PREVOST

SAFETY RECALL

SR13-72

DATE : DECEMBER 2013	SECTION : 03 - Fuel
SUBJECT: ACCELERATOR PEDAL INSPECTION

PART 1 – CHECKING ACCELERATOR PEDAL SERIAL NUMBER

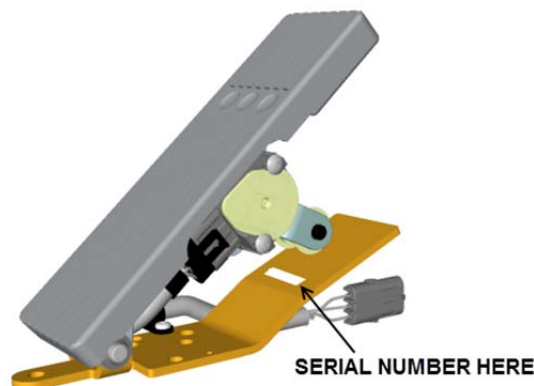
1. Check the serial number on the accelerator pedal assembly.
2. If the accelerator pedal serial number matches with a serial number found in the following list, a replacement of the accelerator pedal is needed. To do so, perform Part 2 of this campaign.
3. If your accelerator pedal serial number is not within the range of affected accelerator pedal, no replacement is needed. No other verification or repair is necessary.

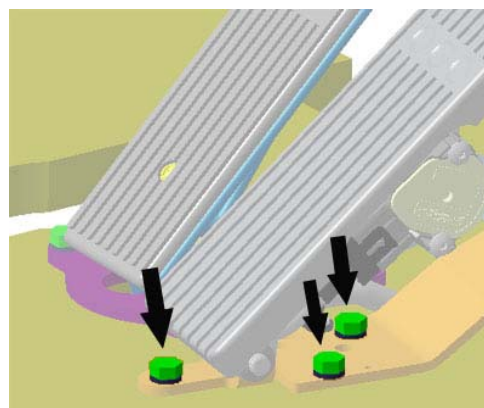
1. Remove accelerator pedal mounting bolts (3x).

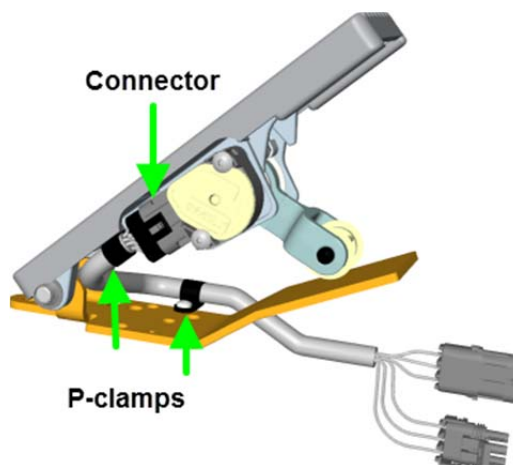
2. Unscrew the electrical harness P-clamps (2x).
3. Unplug the connector from the acceleration pedal. Unless it is in bad condition, reuse the existing harness and connect it to new accelerator pedal.
4. Plug connector to new acceleration pedal. Secure P-clamps onto the new acceleration pedal.
5. Bolt the new accelerator pedal to the floor using the existing hardware.
6. Start the engine. With the parking brake applied and transmission in neutral position (N), test the accelerator pedal for proper functioning.
